RE: SUPPLEMENTAL PUBLIC COMMENTS AND TECHNICAL NOTE ON THE JOINT APPLICATION OF ENBRIDGE ENERGY TO OCCUPY GREAT LAKES BOTTOMLANDS FOR ANCHORING SUPPORTS TO TRANSPORT CRUDE OIL IN LINE 5 PIPELINES IN THE STRAITS OF MACKINAC AND LAKE MICHIGAN [NO. 2HB-VGKO-35JE]

## Technical Note

## <u>Regarding Enbridge Line 5 Non-Compliance with 1953 Easement Requirements</u> <u>A Mechanistic Analysis of Straits Pipeline Washout Phenomena</u>

Figure 1. Soil Particle Entrainment Velocity as a Function of Underwater Current Velocity

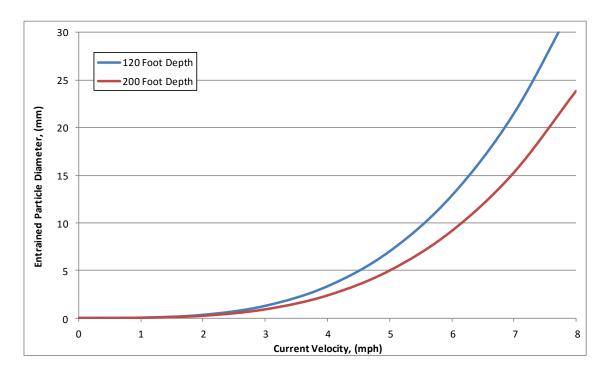
Although much has been published about the problem with washouts under Line 5 with resultant lack of support and easement violations, it does not appear that the mechanism causing this problem has been previously elucidated. Washouts occur because of currents that are fast enough to entrain soil particles and move them away from beneath the pipe. Figure 1, calculated from the Levillain<sup>3</sup> equation, illustrates the extremely nonlinear nature of the soil entrainment process. This figure shows that at currents below the design maximum of 2.26 mph no soil particles larger than 0.5mm can be entrained. This velocity is sufficient to entrain silt and small sand particles but is not capable of moving most soil particles. Because the Levillain equation is highly nonlinear, current speeds greater than this value have a disproportional impact on the size of soil particles that can be entrained and transported. A three mph current will entrain particles with diameters on the scale of a millimeter which includes typical lake bottom sand and a six mph current can transport small rocks with diameters on the order of one half inch. This knowledge leads to the conclusion that pipeline washouts occur during events that cause extreme currents which are most likely found in turbulent eddy flows resulting from exceptional weather events across the Great Lakes Basin.

An analysis of the current data taken in the Straits by Saylor and Miller in 1991<sup>7</sup> shows that the original designers of Line 5 seriously underestimated the strength of the currents impacting the structure. This data shows that 15 minute average currents near Line 5 can exceed the design basis for several hours each year and that at some times the currents exceed 4 mph. It is probable that Line 5 washouts are caused by local turbulent eddies with peak velocities over 6 mph that occur infrequently likely during seiche inducing Derecho events or other extreme weather events. Due to the limited data available about extreme currents under the Straits and the probabilistic nature of the washout process, it is very difficult to predict when and where washouts will occur. Additionally, because of both marine fouling and current loadings well beyond the design basis, it is likely that the original stress calculations that resulted in the 75 foot maximum unsupported span requirement underestimate stresses in the pipe and the 75 foot requirement no longer results in the safety margins originally contemplated in the 1953 easement agreement. These errors also affect the calculation that predicts severe consequences should an unsupported span over 140 feet develop. Given currents above the design basis and severe biofouling, the stresses predicted to occur at a 140 foot span are underestimated and severe consequences may occur at unsupported spans less than this length.
